Steam Generator Inspection Program and Results

Answers to Questions

Indian Point Unit No.2
Docket No. 50-247
May, 1978

Maps of locations of Tubes Which
Did Not Permit Passage of the
700 Mil Probe

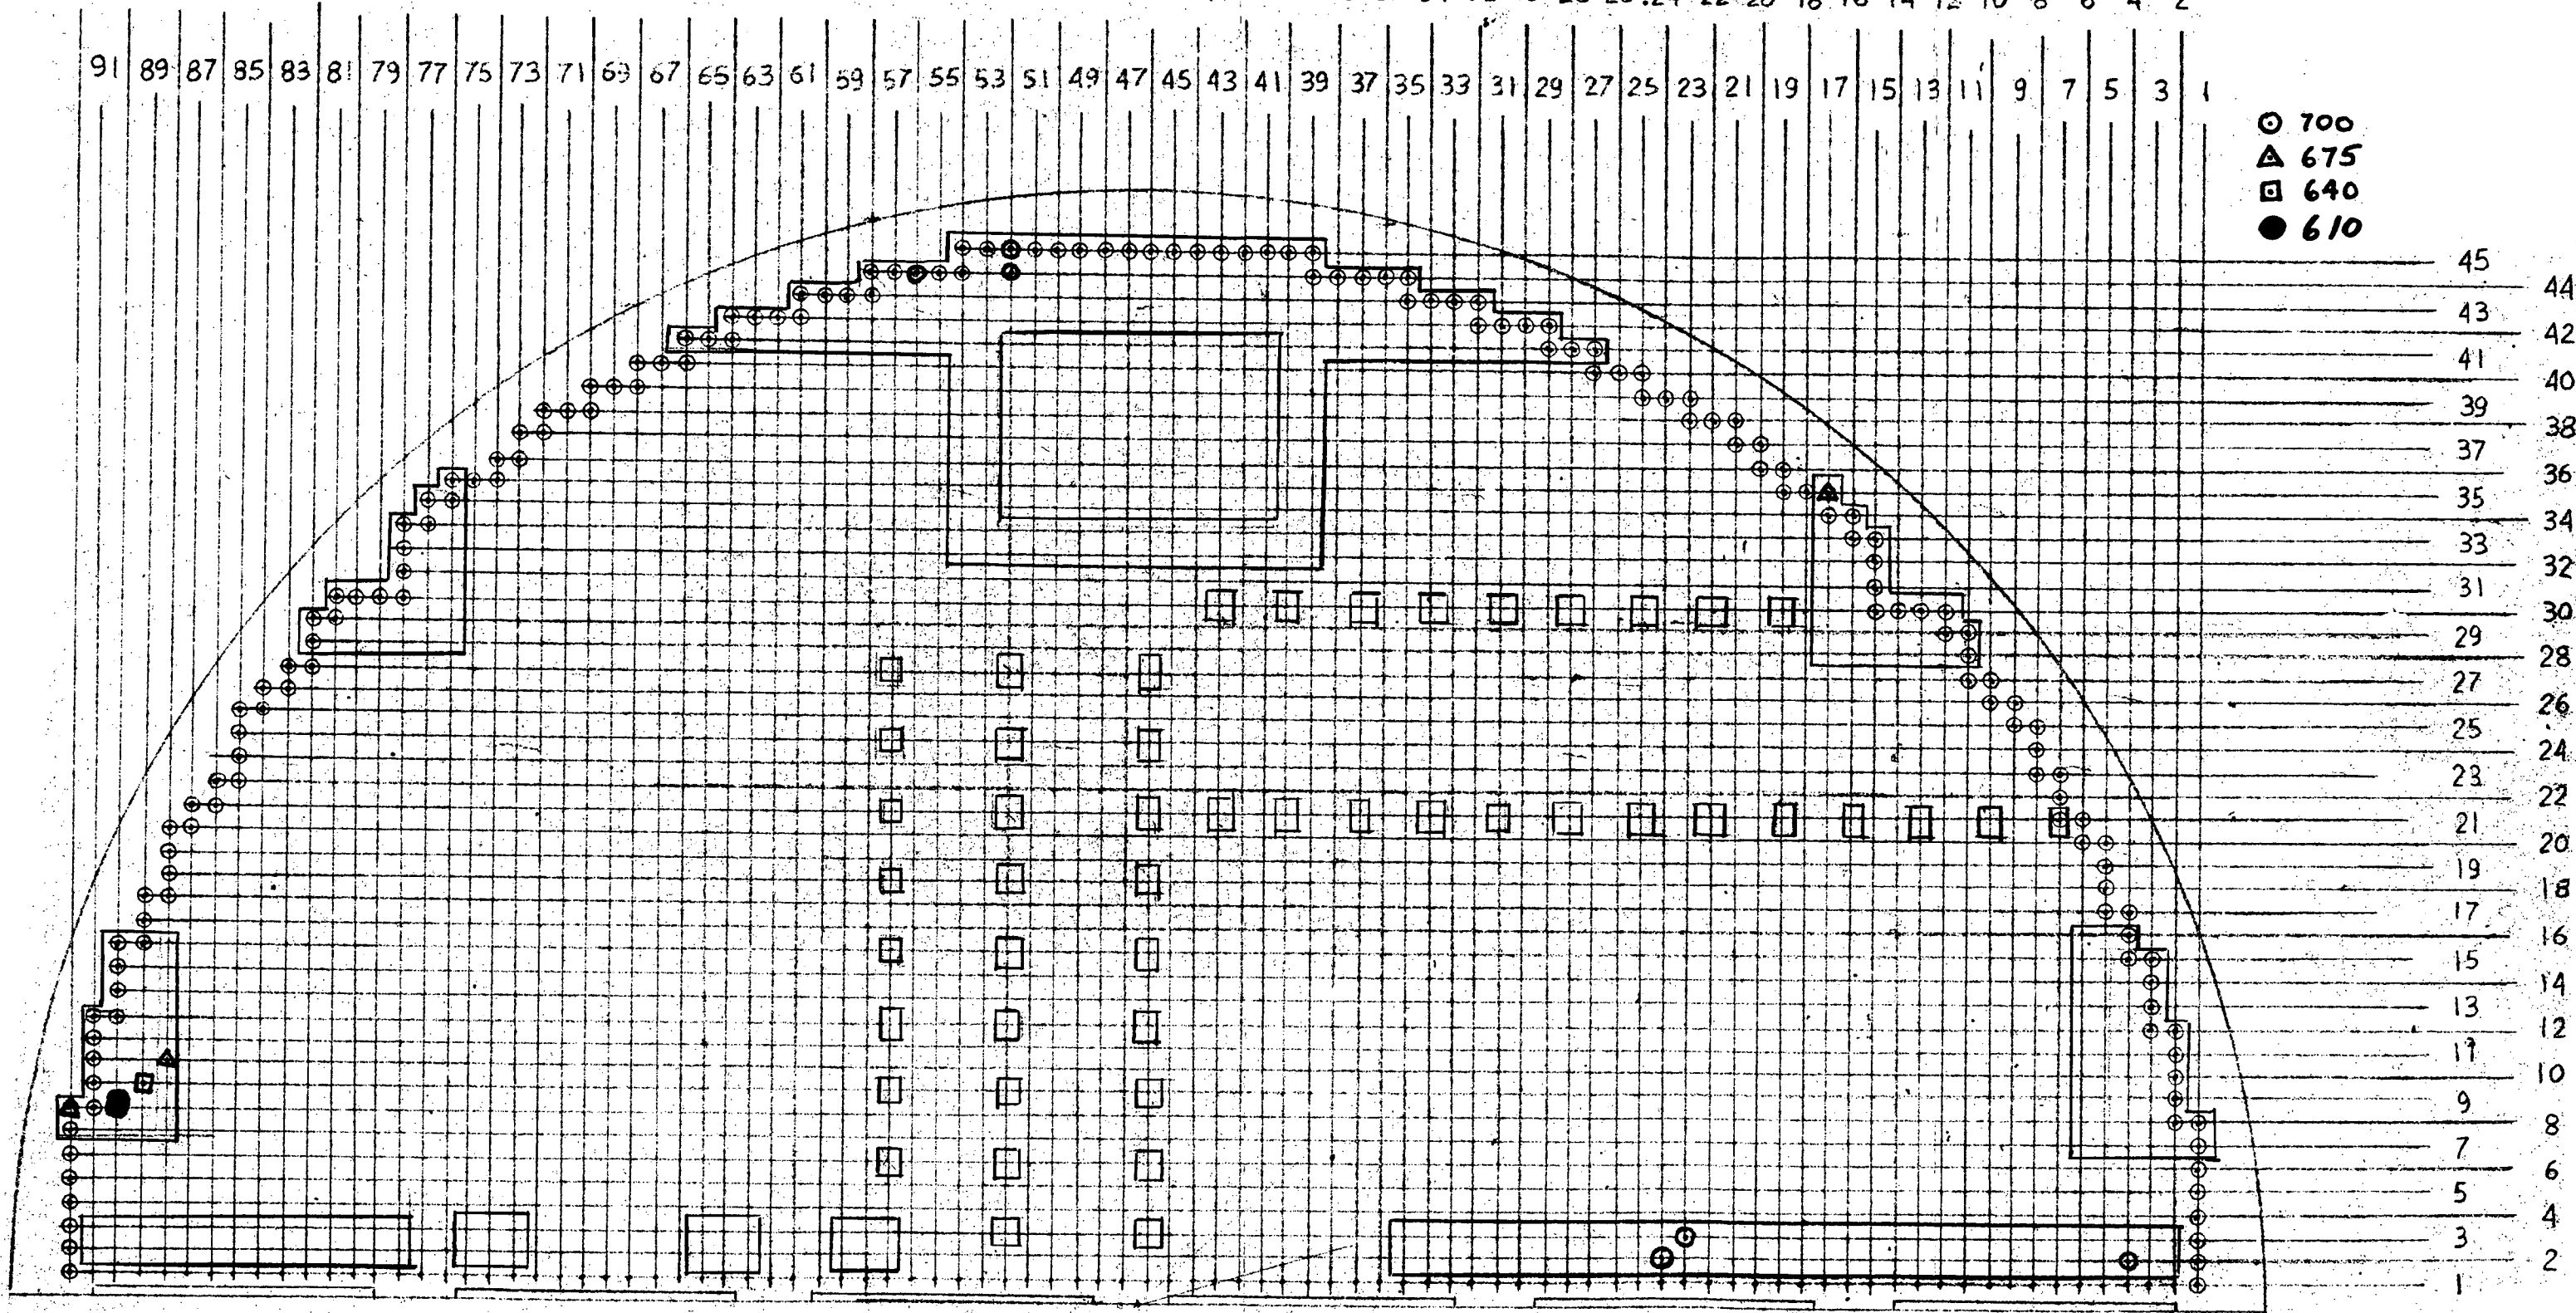
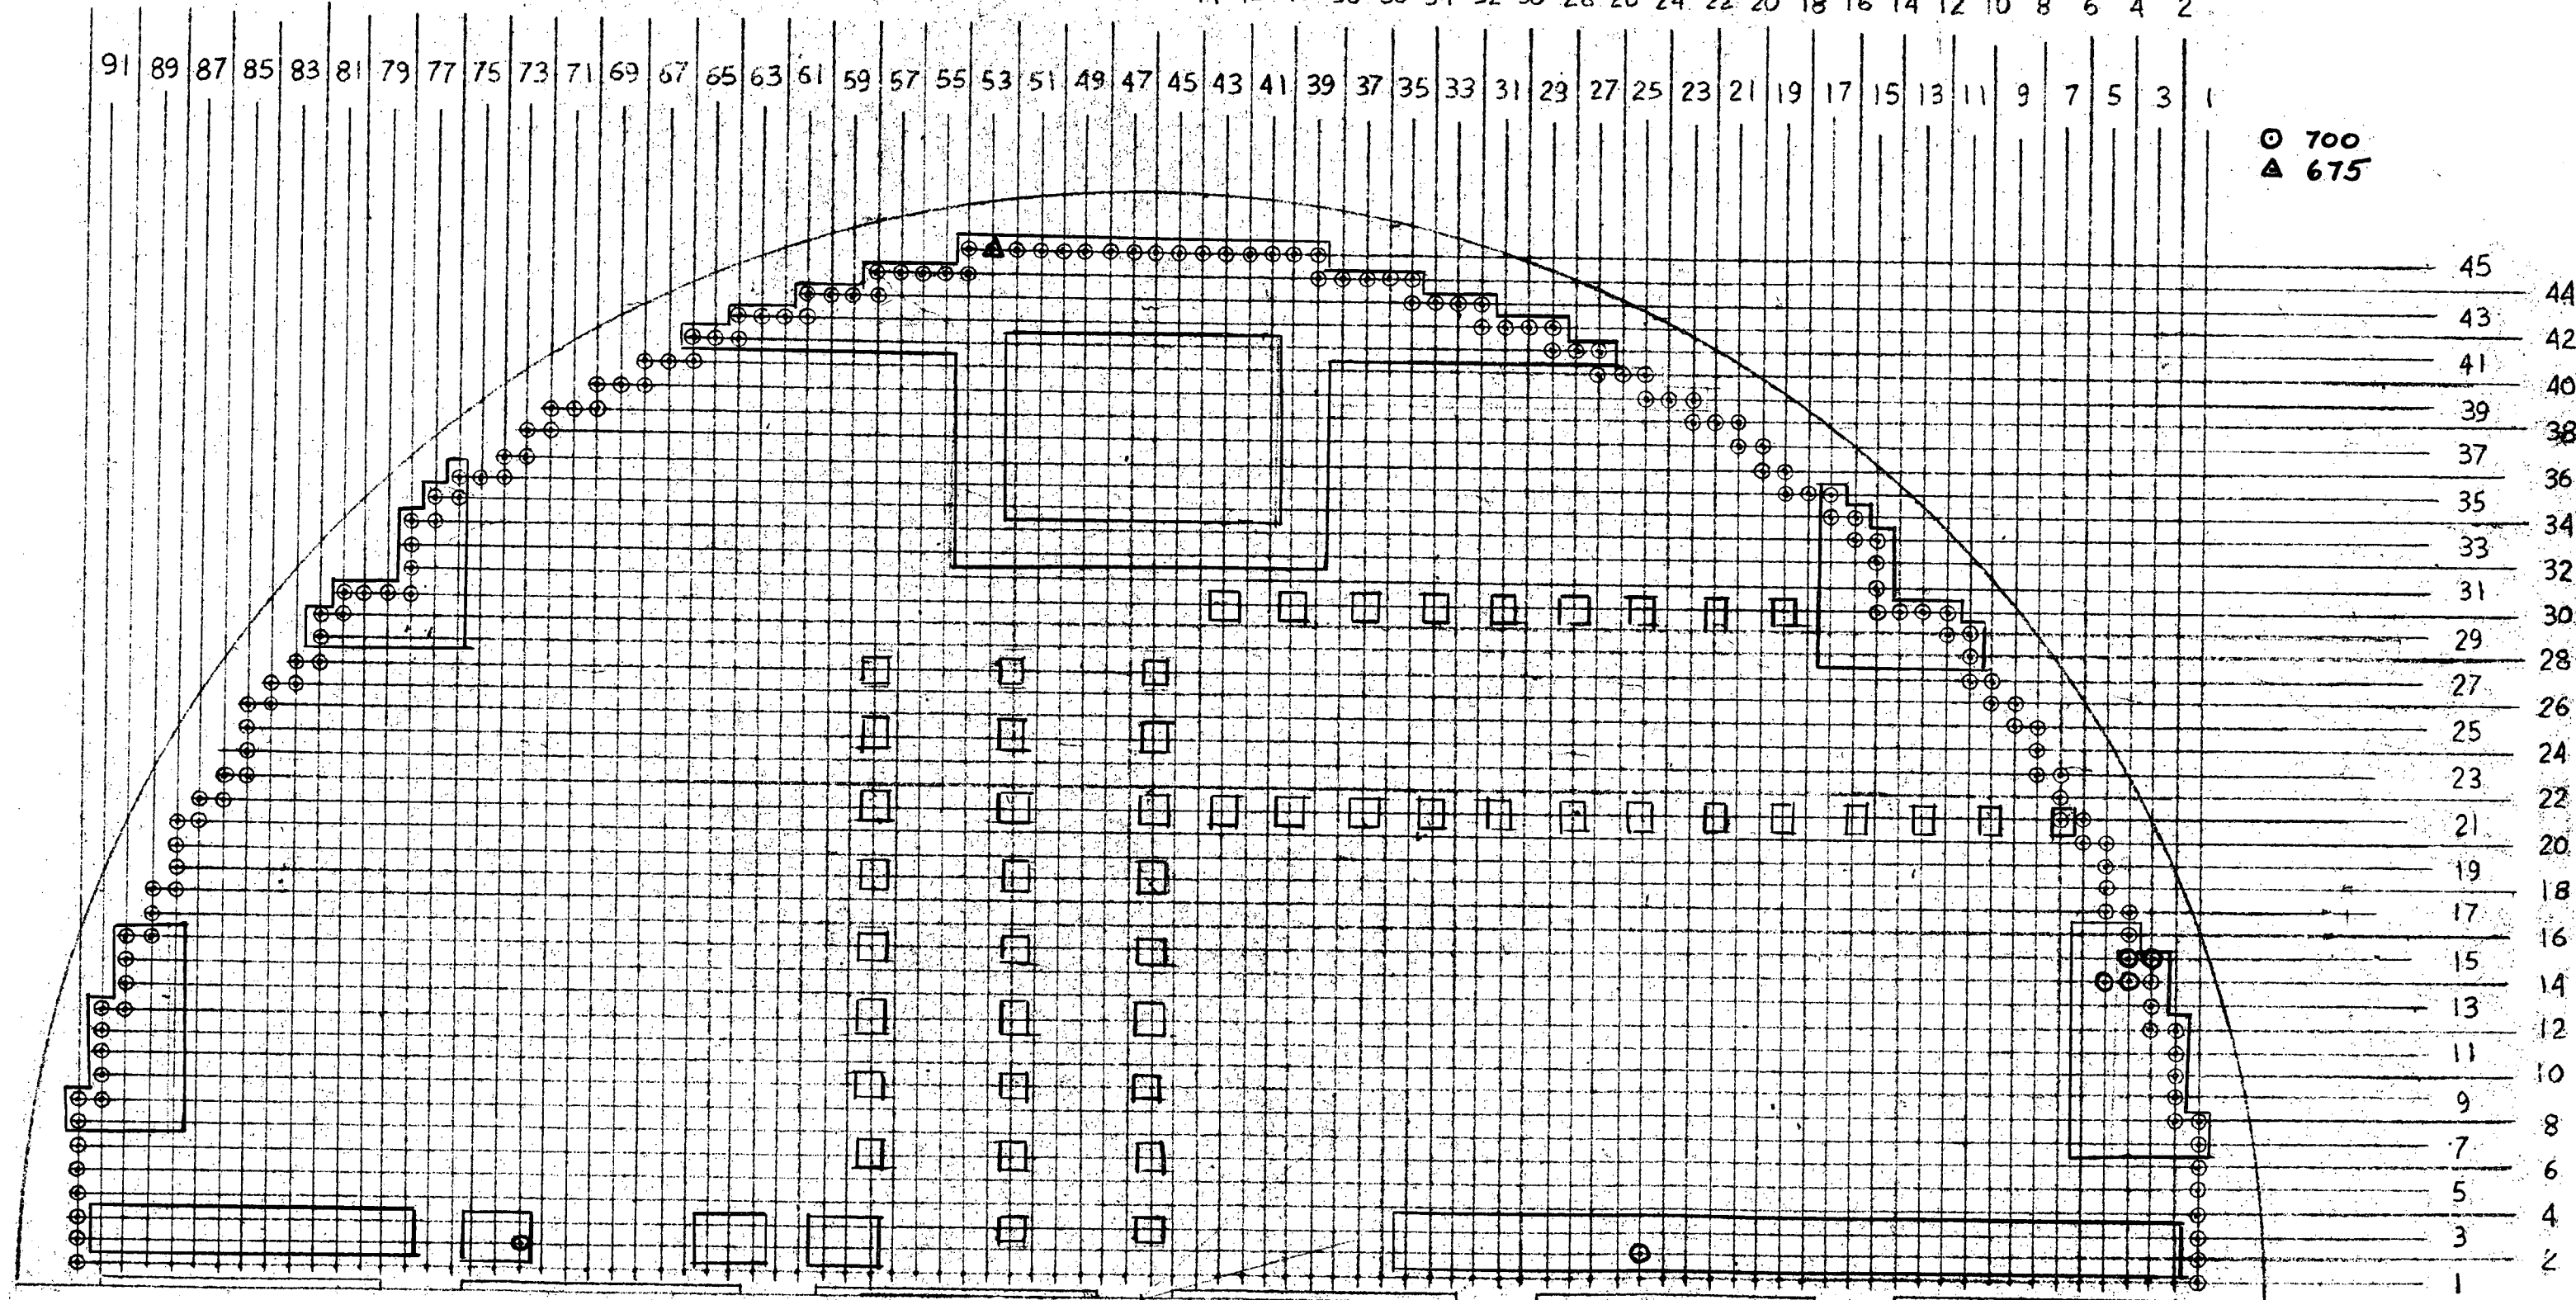
Please provide a map which shows the locations of steam generator tubes tested during the March, 1978 inspection which did not permit passage of the standard 700 mil eddy current probe.

Maps of the locations of all tubes which did not permit passage of the standard 700 mil probe are forwarded as Attachment B to this letter. These locations are coded to indicate the smallest probe size that would not pass through the tube. Those tubes for which the 700 mil probe was the smallest probe size not able to pass through the tubes are indicated by the heavily drawn circle at those tube locations.

The distribution of tubes which permitted passage of probes smaller than the 700 mil diameter probe is slightly different from that shown in our March 24, 1978 submittal because the tubes were reprobed and the data tabulated below is the most recent:

<u>Steam Generator 23</u>		<u>Steam Generator 24</u>	
<u>Smallest Probe Not Passed by Tube</u>	<u>Number of Tubes</u>	<u>Smallest Probe Not Passed by Tube</u>	<u>Number of Tubes</u>
700 mil	28	700 mil	55
675 mil	16	675 mil	7
640 mil	1	640 mil	2
610 mil	1*	610 mil	3*
540 mil	1*	540 mil	3*

*Plugged during 3/78 inspection program
